SUNDRY NOTICES AND REPORTS ON WELLS

SJ 29-6 Unit #18B

DK & complete MV

**CURRENT WELLBORE
PLANNED DK PA SCHEMATIC
SJ 29-6 Unit #18B**

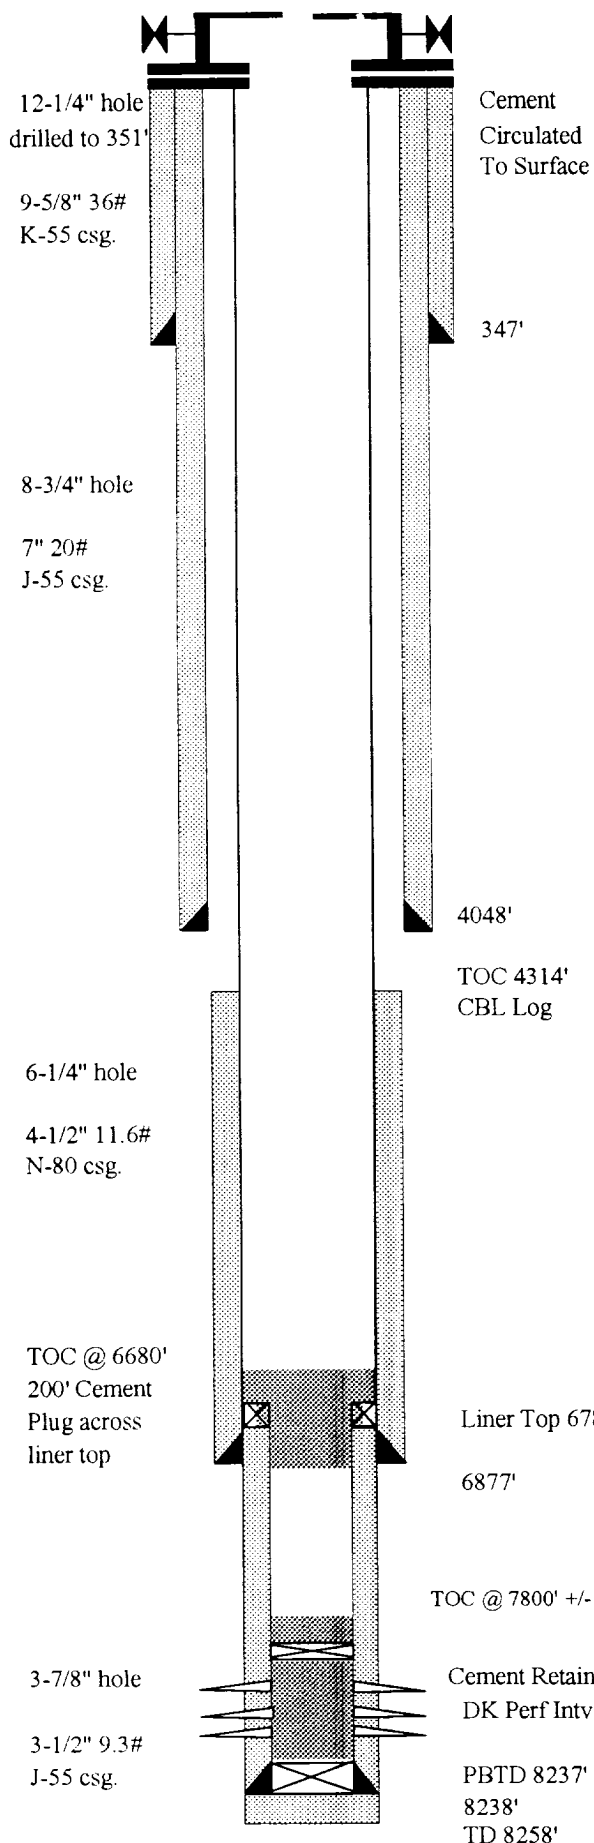
Phillips is requesting permission to P&A the Dakota interval of this well to eliminate the problems associated with the water the Dakota makes. Since the Dakota interval makes such a minimal amount of gas, it hasn't been economical to keep the Dakota interval open. Once BLM approval is obtained, we will still have to obtain Partner approval before we will start the work.

Set 3-1/2" Cement retainer at 8000' +/- approx. 60' above top of perforated interval. Establish injection & pump 3-4 bbls cement below the retainer. Unsting from retainer and spot a 200' cement plug on top of the retainer. POOH to 6880' and set second cement plug from 6880' to 6680' across the 3-1/2" liner top. POOH and proceed with Mesaverde completion as planned in the APD which will add perforations from 5492' - 6005' & later 4443' to 4919' in the Lewis Shale intervals. This will then be as single MV well.

TOC @ 7800' +/-

Cement Retainer @ 8000 +/-
DK Perf Intv 8060'-8193'
